# Product Change Notification (PCN)

PCN #: 12B-2021

DATE: 15<sup>th</sup> December 2021

**BT730-SA-01 / BT730-SC-01/ BT730-SA-01-HW**

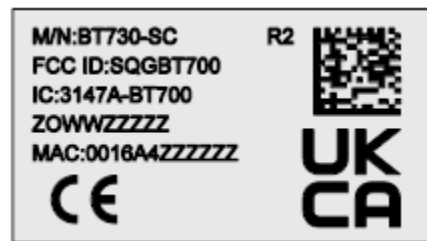
Revision code change from rev 01 to R2. See the following pictures

**BT740-SA-02 / BT740-SC-02**

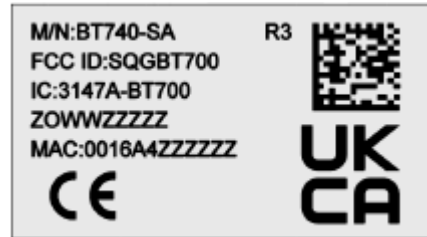
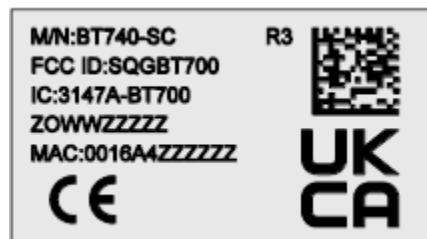
Revision code change from rev02 to R3. See the following pictures

**5.2 Shipping Carton Labels**

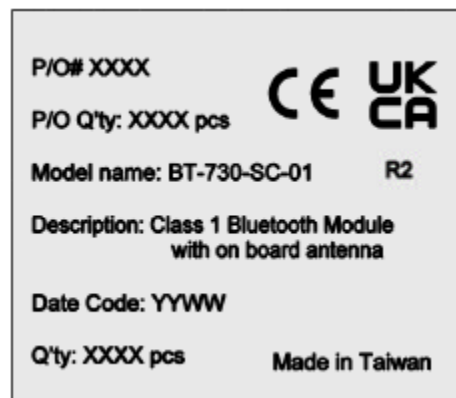
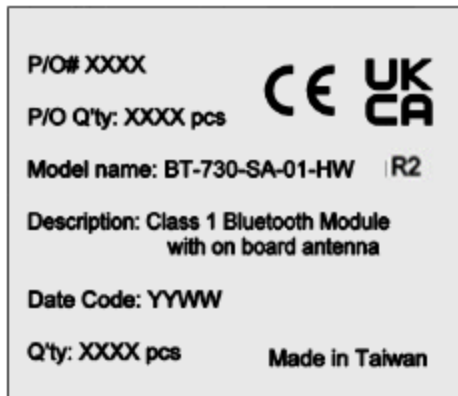
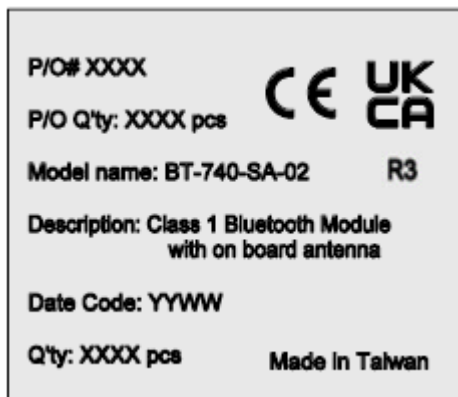
- Adding revision on carton label
